**-ADDENDUM NUMBER 2**

**May 2, 2023**

**PROJECT:  
CITY OF MOBILE PARK IMPROVEMENTS**

**GMC PROJECT NO. AMOB220095**

## VAK PAK CB416 SERIES CABINET DETAILS

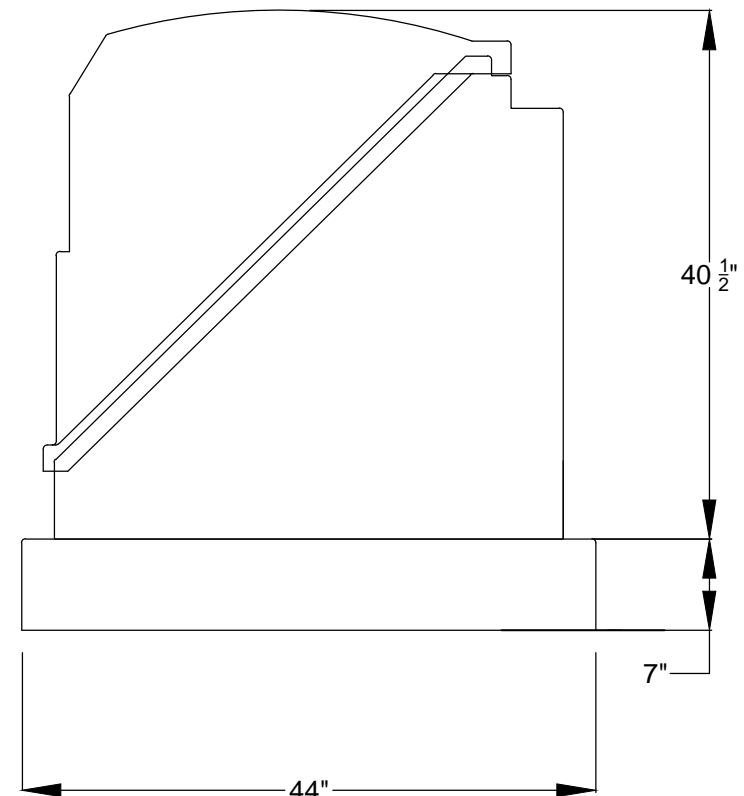
1. Added CB416 Cabinet Details to Addendum #2 for Baumhauer splash pad equipment.
